Item Name: Skidtube (Fits LH or RH)

DART SERVICE INSTRUCTION

TO AMEND INSTALLATION INSTRUCTIONS IIN-D117-762 REV. A AND
INSTRUCTIONS FOR CONTINUED AIRWORTHINESS ICA-D117-762 REV. 0

A	NEW ISSUE	PH	08.12.04
REV.	DESCRIPTION	BY	DATE
DESIGN	PH	DART AEROSPACE USA, INC PORT HADLOCK, WA	
DRAWN	PH		
CHECKED		DRAWING NO.	REV. A
MFG. APPR.	N/A	DSI 9435	SHEET 1 OF 2
APPROVED		TITLE	SCALE
DE APPR.		GROUND HANDLING HARDWARE CHG NTS	
DATE	08.12.04	<small>COPYRIGHT © 2008 BY DART AEROSPACE USA, INC</small> <small>THIS DOCUMENT IS PRIVATE AND CONFIDENTIAL AND IS SUPPLIED ON THE EXPRESS CONDITION THAT IT IS NOT TO BE USED FOR ANY PURPOSE OR COPIED OR COMMUNICATED TO ANY OTHER PERSON WITHOUT WRITTEN PERMISSION FROM DART AEROSPACE USA, INC.</small>

SECTION A-A
2 PL PER SKIDTUBE

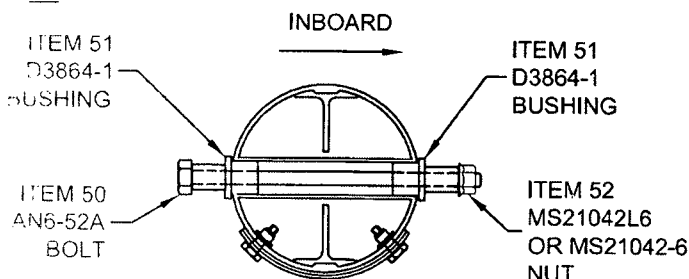
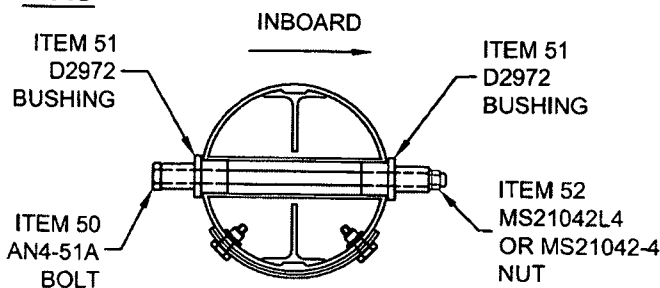
ON D117-762-011 SKIDTUBES AT CHG 002, THE GROUND HANDLING HARDWARE HAS BEEN REPLACED WITH AN6-52A BOLT (1), D3864-1 BUSHING (2), AND MS21042L6 NUT (1) AS SHOWN BELOW. TORQUE TO 95-110 IN-LBS (10.7-12.4 N-M). AMEND PARTS LIST IN SECTIONS 5.1 OF INSTALLATION INSTRUCTIONS IIN-D117-762 REV. A AND SECTION 32.8 OF THE INSTRUCTIONS FOR CONTINUED AIRWORTHINESS ICA-D117-762 REV 0 AS SHOWN ON PAGE 2 OF THIS DOCUMENT.

IS

WAS

SECTION A-A
2 PL PER SKIDTUBE

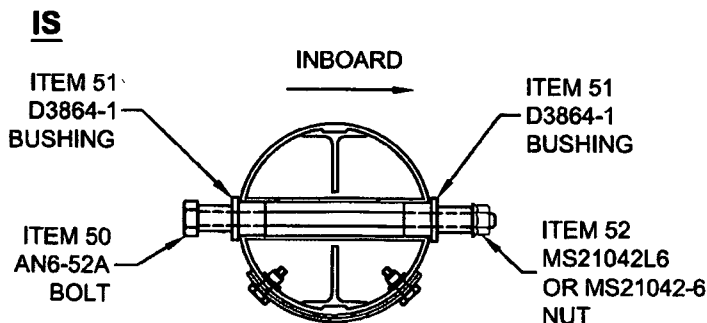
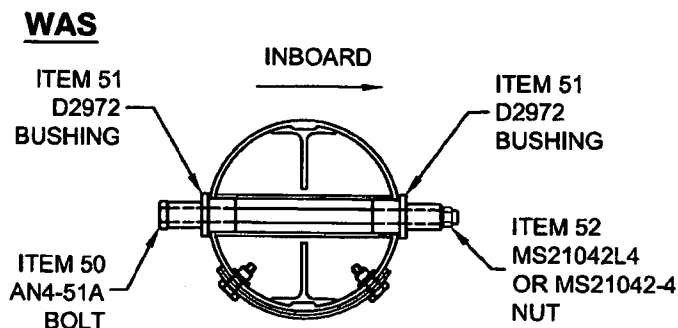
ON D117-762-011 SKIDTUBES AT CHG 002, THE GROUND HANDLING HARDWARE HAS BEEN REPLACED WITH AN6-52A BOLT (1), D3864-1 BUSHING (2), AND MS21042L6 NUT (1) AS SHOWN BELOW. TORQUE TO 95-110 IN-LBS (10.7-12.4 N-M). AMEND PARTS LIST IN SECTIONS 5.1 OF INSTALLATION INSTRUCTIONS IIN-D117-762 REV. A AND SECTION 32.8 OF THE INSTRUCTIONS FOR CONTINUED AIRWORTHINESS ICA-D117-762 REV 0 AS SHOWN ON PAGE 2 OF THIS DOCUMENT.
